Site Technical Query - Form

TQ Number:		Project:	
CW2144960	-A010- 0069	Oyu Tolgoi Underground Project	
A. To be completed by or on behalf of the Contractor			
Contractor/Sub-Contractor Name:	MCS International	Date Response	27/02/2022
Contract Title:	Booster Fan installations	Plant Area &	1833
Contract No.	CW2144960	Contractor TQ Number:	BF-0415-TQ-0069
Discipline Codes (Mandatory) D1 (CSA) - <input type="checkbox"/> D2 (MP) - <input checked="" type="checkbox"/> D3 (E&I) - <input type="checkbox"/> D4 (Other) - <input type="checkbox"/>			
<i>Description of Technical Query (List affected drawings and specifications):</i> 1833B Fan area : Monorail hoist clashed with target plate rock bolt The monorail hoist installed on the monorail beam is clashing with monorail target plate rock bolt. Refer to the attached field photos.			
<input type="checkbox"/> Routine <input checked="" type="checkbox"/> Urgent Refer Technical Query instructions

0 YU TOLGOI UNDERGROUND PROJECT
5 TONNE
LIFTING EQUIPMENT
ULTRA LOW HEIGHT HOIST

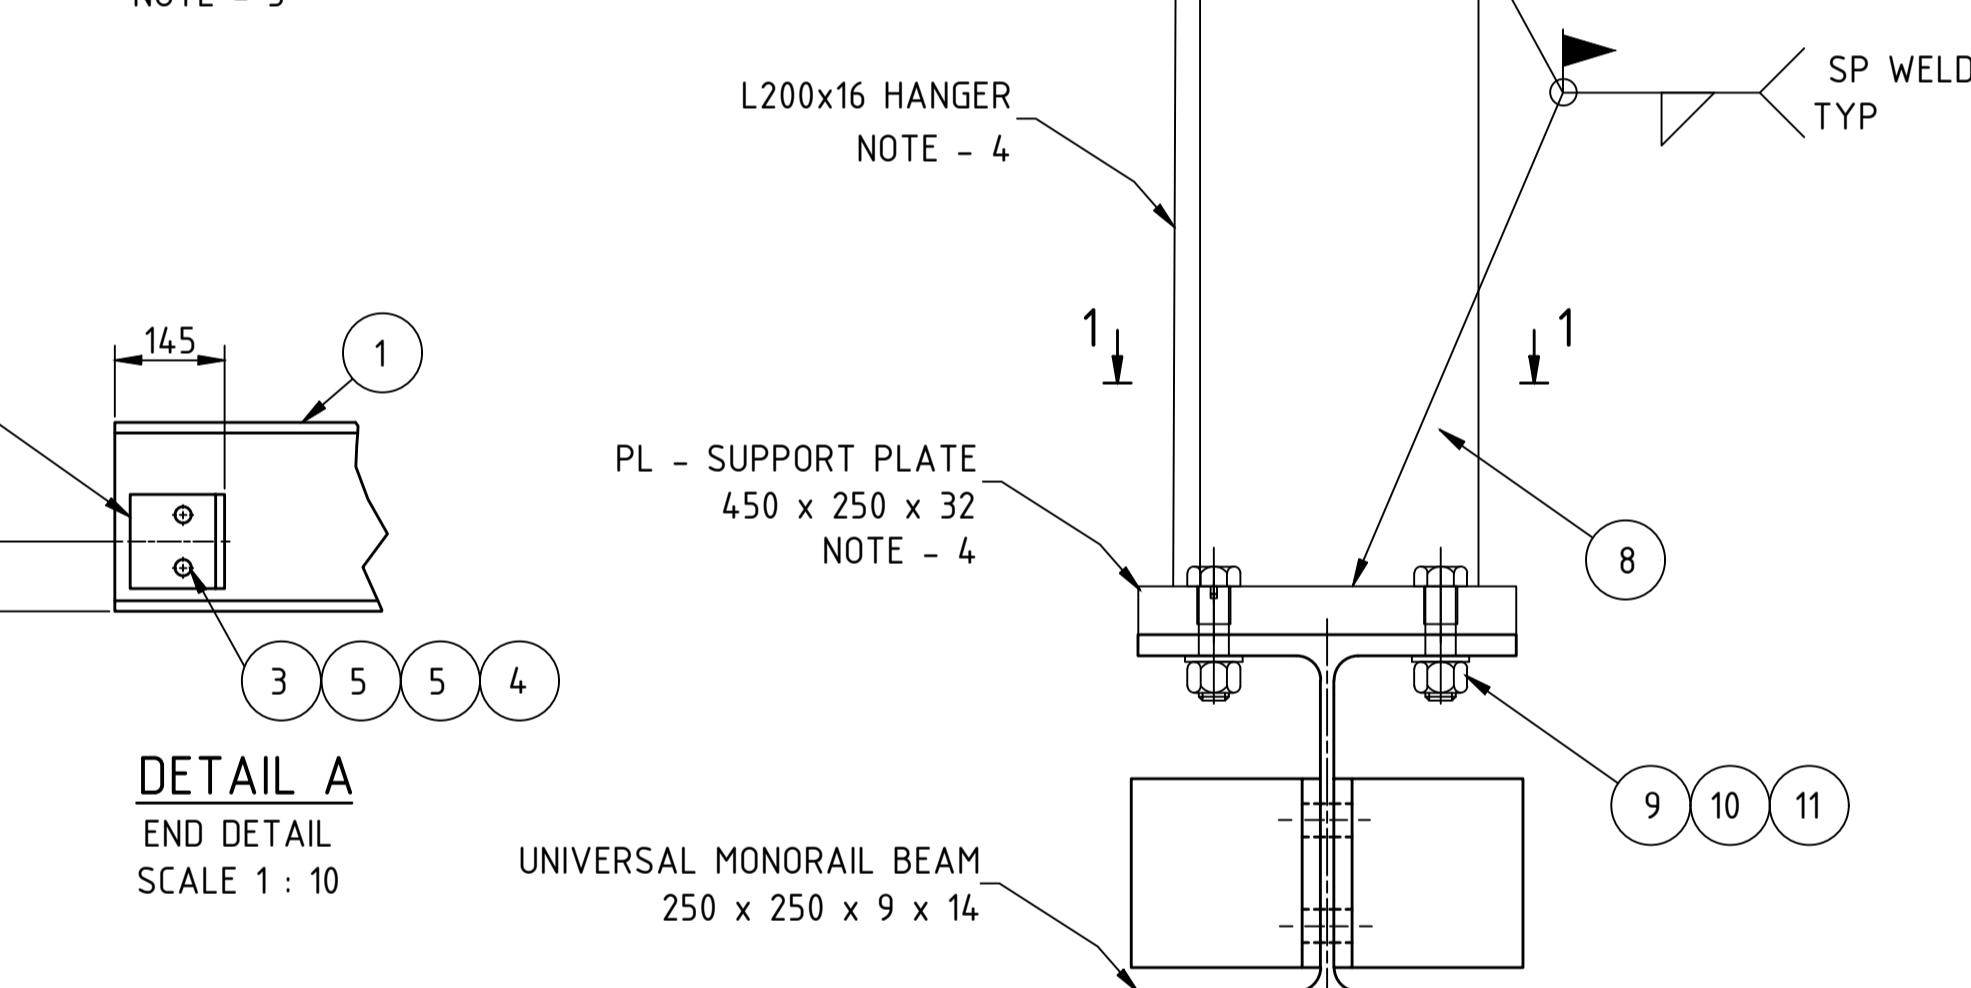
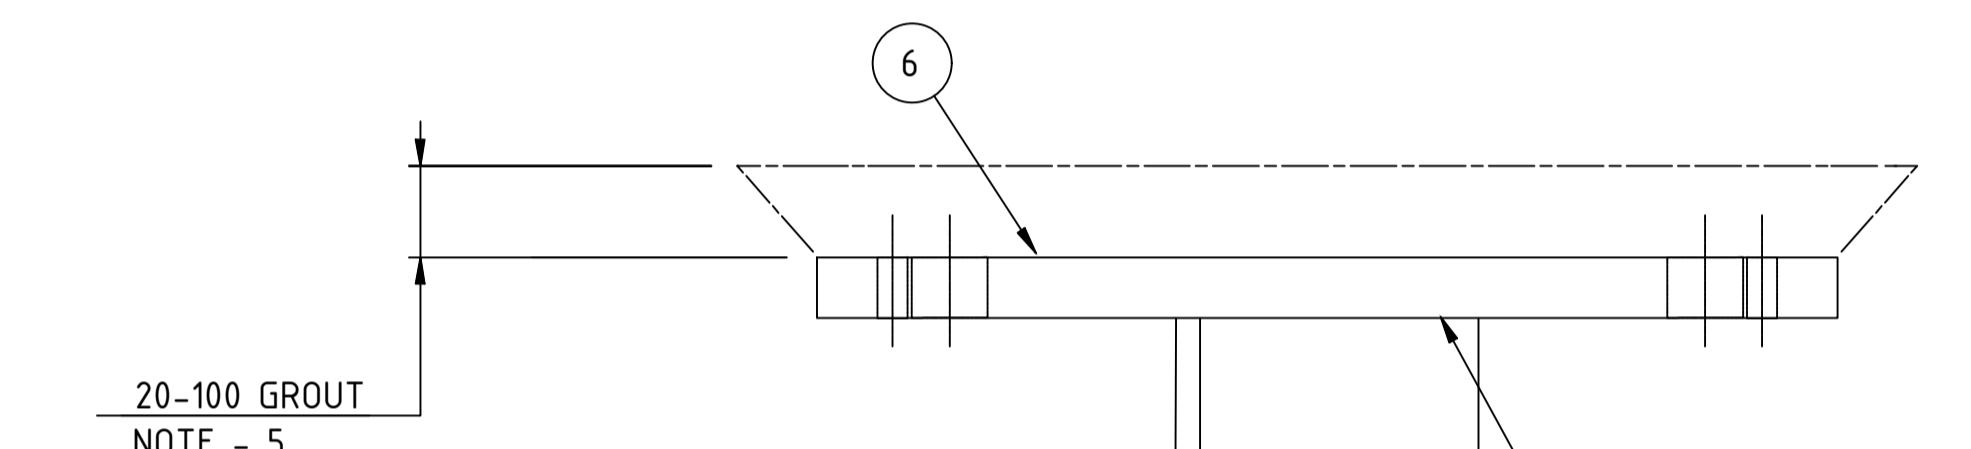
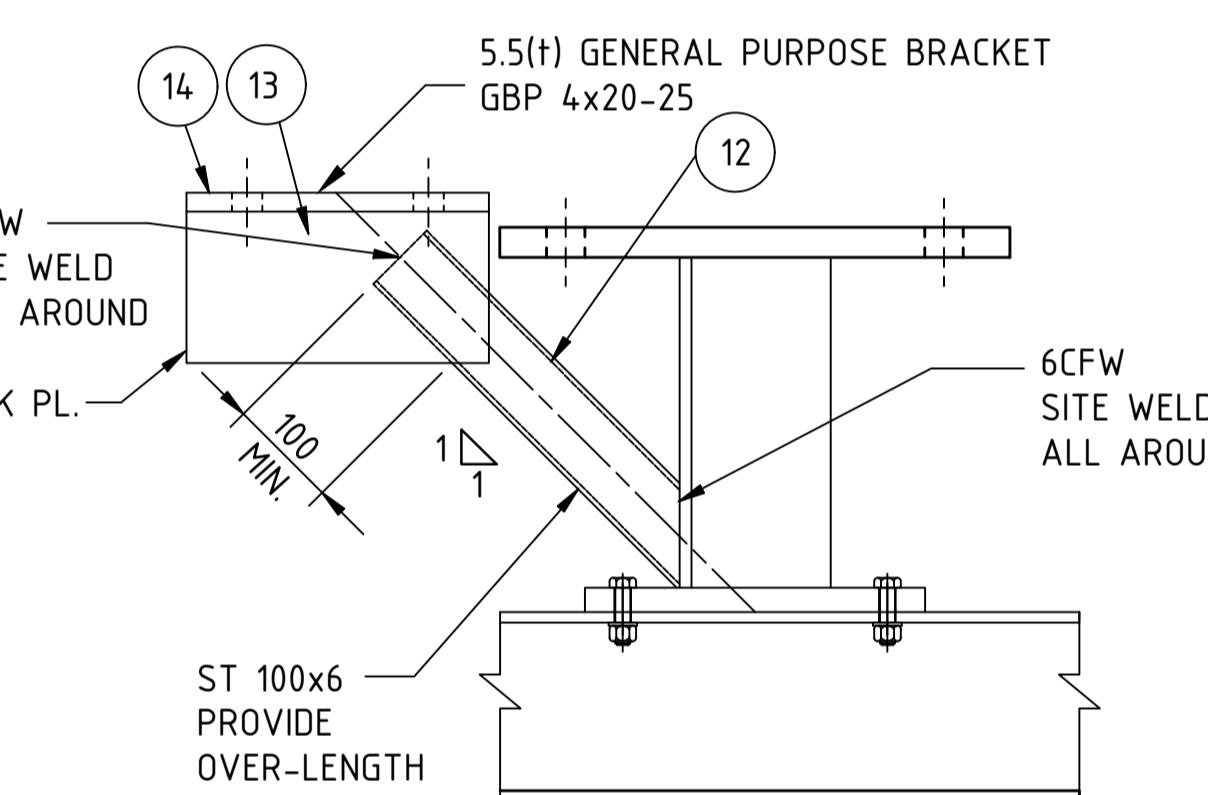
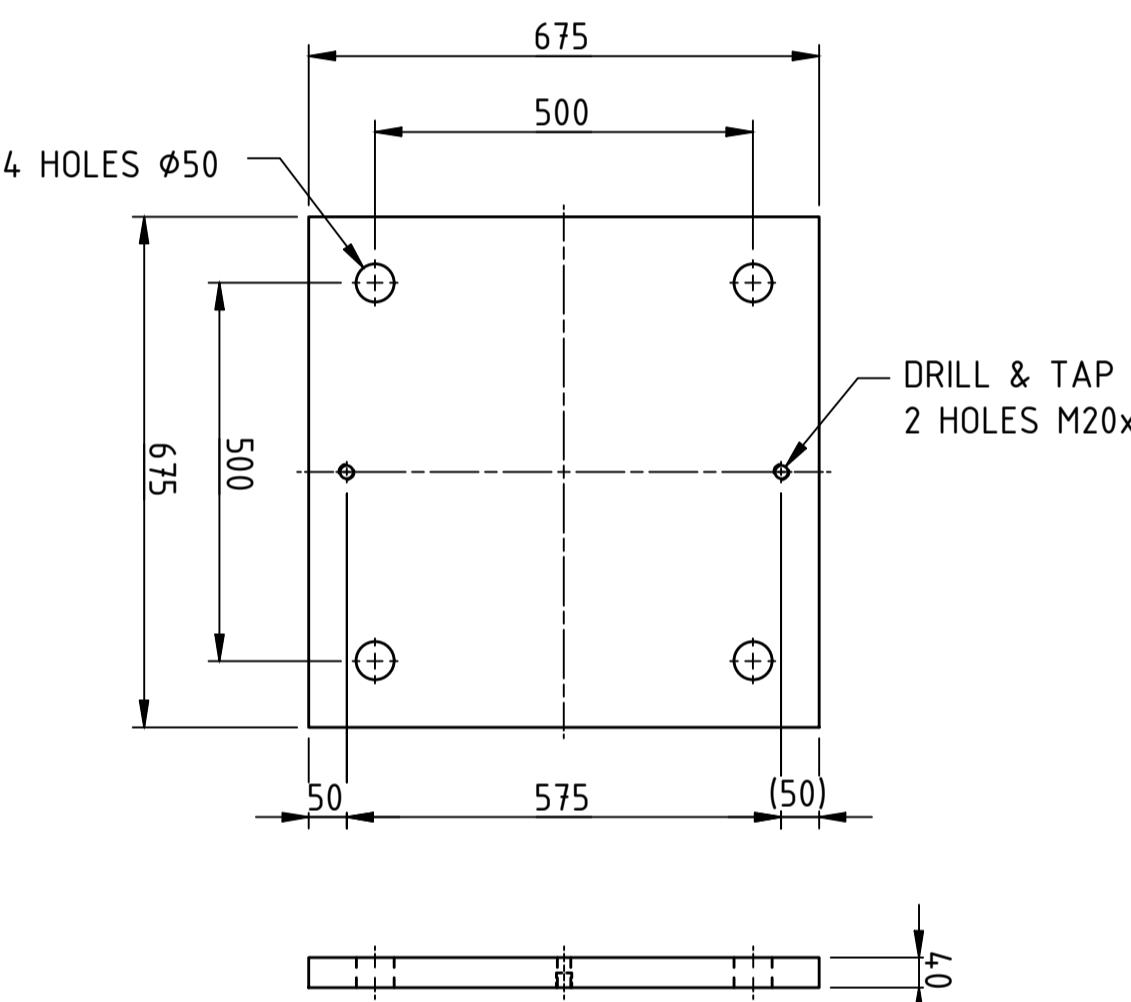
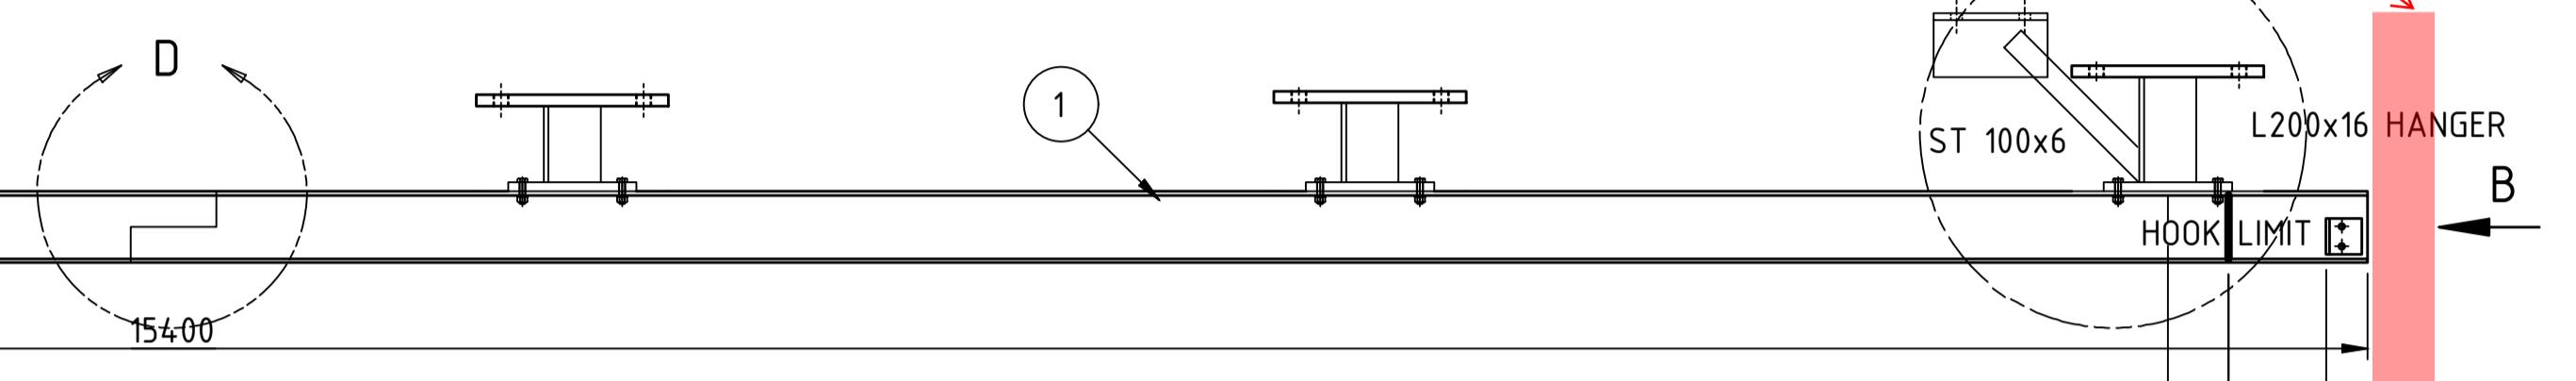
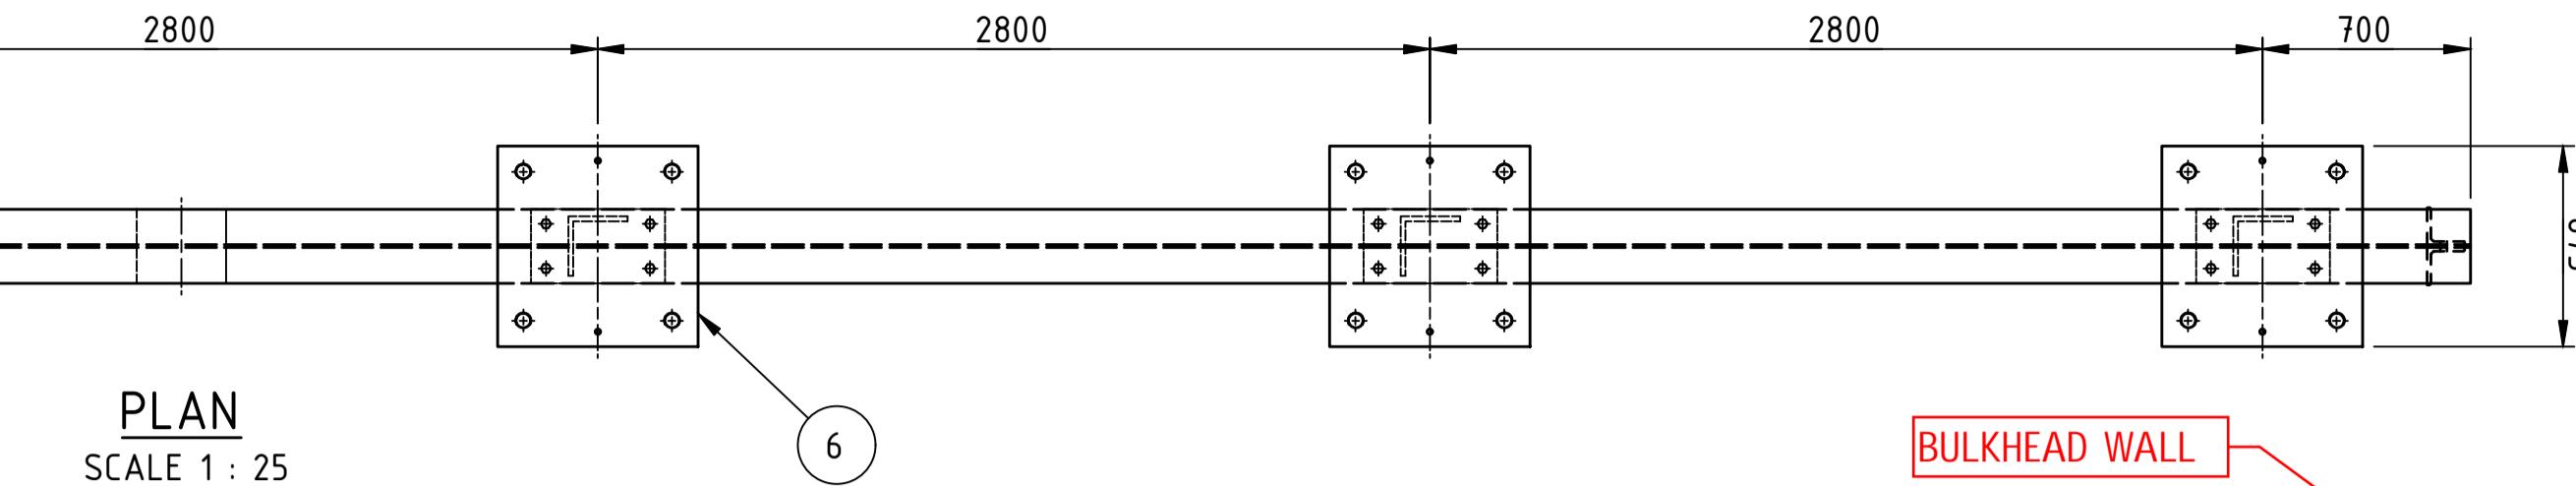
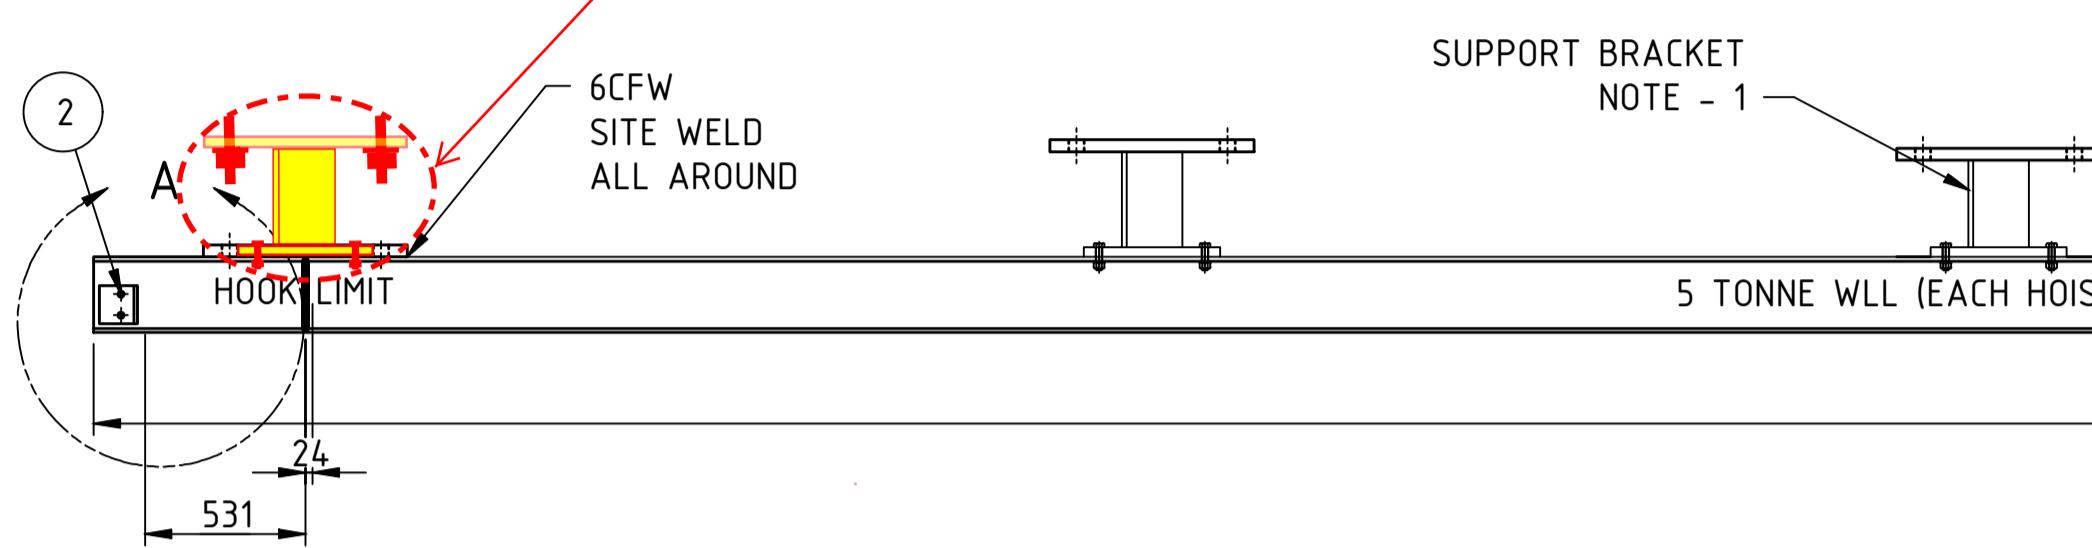
<i>Proposed Action (List all attachments)</i> The contractor is proposed the following option. 1. To demolish the shotcrete top of target plate and target plate grout. Also, to push the target plate. (in page 4)			
Effect on cost (USD):	YES		
Effect on schedule (Days):	YES		
Effect on quality:	NO		
Requested by (Name):	Delgersuren.N	Position:	SMP Engineer
Signature:		Date: (dd/mm/yyyy)	24/02/2022

1. To demolish the shotcrete ceiling part and target plate grout.
2. Push the target plate.
3. To Weld support bracket.
4. To Weld 450x250 plate.
5. To connect the monorail beam with plate by bolts.

Proposal is acceptable subject to following comments:

- Demolish existing grout completely and chip shotcrete surface to create a room for additional vertical L20 as required;
- Push target plate as much as possible within angle tolerance as specified in standard drawings;
- Re-grout target plate and pre-tension rock bolts. Cut projection of rock bolts maintaining minimum 3 threads beyond the nut after completion of works.
- Note that the chipping of the shotcrete is to be made subject to inspection and agreement by OT Geotechnical engineer.
